PACIFIC GAS AND ELECTRIC COMPANY

May 17, 1984

PGandE Letter No.: DCL-84-186

Re: Docket No. 50-275, OL-DPR-76
Docket No. 50-323
Diablo Canyon Units 1 and 2
Responses to SSER 22

FIGURE 1

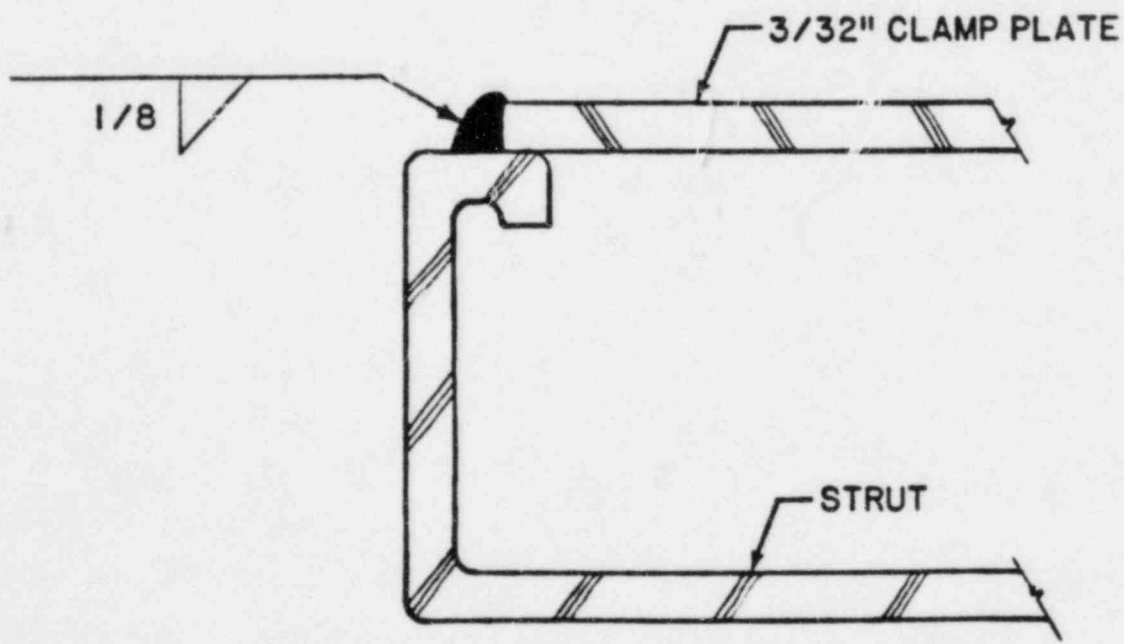
This clamp modification was specified for only a few raceway cable tray supports in Unit 2. When Foley began construction of these modifications, they found that the existing clamps were not wide enough to place the specified weld as the joint configuration shown in Figure 2 of Exhibit 2, attached, actually existed. For the Figure 2 joint configuration, placement of a 1/8" weld on the end of the 3/32" clamp plate would have been inappropriate. However, in the course of the normal DCN review process, Foley initiated an Engineering Disposition Request, notifying Engineering of the

Welds of 1/8 inch were specified for use with the joint configuration shown in Figure 1 of Exhibit 2, attached. For this configuration, making a 1/8 inch weld to a 3/32 inch clamp plate is acceptable and is in conformance with the AWS D1.1 welding code.

actual condition. Engineering then revised the design. The existing clamp plates were replaced with wider clamp plates, restoring the Figure 1 joint configuration. Proper welds were then made. Alternately, in a few cases, the clamp was replaced with a clip angle that bolted to both the tray and the strut, thus eliminating the need for welding.
